Technical Note 1	
Leeds Road, Kirklees	
Job number:	J0737
Document number:	J0737/2/D1
Date:	18 January 2024
Client:	c/o KPP Architects
Prepared by:	Mr Bob Thomas

1.1.1 This technical note provides a response to comments made by Kirklees Council on the Air Quality Assessment submitted in support of the outline planning application for a warehouse at Leeds Road, Mirfield, application number 2023/60/92448/E. Kirklees Council Environmental Health (Pollution & Noise Control) provided a response on 11th September 2023, responding reference WK/202327411. With specific reference to air quality, the following comments have been made by Kirklees Council:

Figure 1: Measured Annual Mean NO₂ Concentrations at Diffusion Tube K6

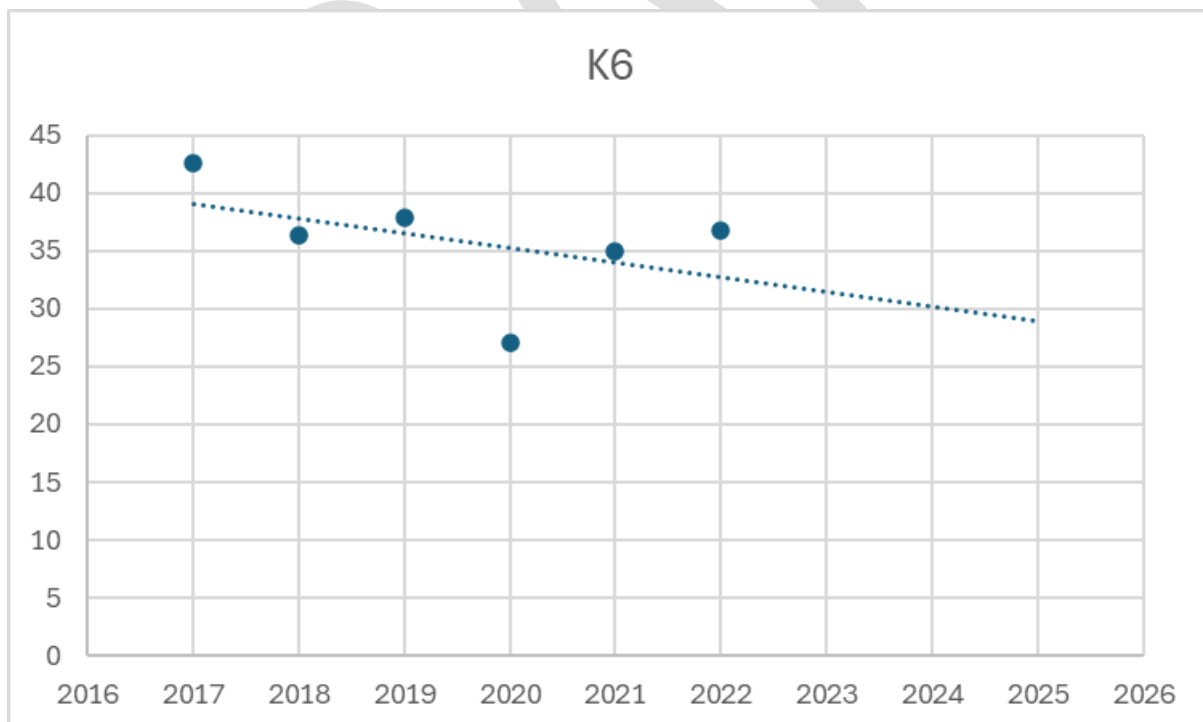
K6 is the nearest roadside diffusion tube to Rose Cottage R1. According to our latest monitoring figures taken from the 2023 ASR which is yet to be approved by DEFRA, the 2022 annualised concentration for K6 at roadside is 36.8 $\mu\text{g}/\text{m}^3$ and at the nearest receptor façade is 31.2 $\mu\text{g}/\text{m}^3$. However, the predicted modelled concentration for the 2025 Do Minimum (DM) and Do Something (DS) scenarios as depicted in the assessment is 20.0 $\mu\text{g}/\text{m}^3$ respectively. This would suggest a reduction of 11.2 $\mu\text{g}/\text{m}^3$ over 3 years, this requires further explanation given the nature of this extremely busy junction.

- 2.3.4 Measured annual mean NO₂ concentrations at diffusion tube monitoring site K6 are represented in a graph in **Figure 1**. The graph also shows a trendline projected forward to 2025. There is a falling trend in annual mean NO₂ concentrations, with a projected annual mean concentration of around 29µg/m³ at diffusion tube monitoring site K6 in 2025. The annual mean NO₂ concentration predicted at diffusion tube monitoring site K6 in 2025 without the proposed development is 21.4µg/m³. Therefore, assuming annual mean NO₂ concentrations continue to decrease at diffusion tube monitoring site K6 at the same rate as between 2017 and 2022, the model may underpredict concentrations at this location.

- 2.3.5 Receptor R1 is close to diffusion tube monitoring site K6, but at the façade of a dwelling approximately 9m further from the kerb of the A62 than the monitoring site. The predicted annual mean NO₂ concentration at receptor R1 is 1.4µg/m³ lower than

at the monitoring site in 2025. Therefore, an estimate of the 2025 annual mean NO₂ concentration at receptor R1, based on the decreasing trend in annual mean concentrations at diffusion tube monitoring site K6, is around 28µg/m³, well below the annual mean objective of 40µg/m³.
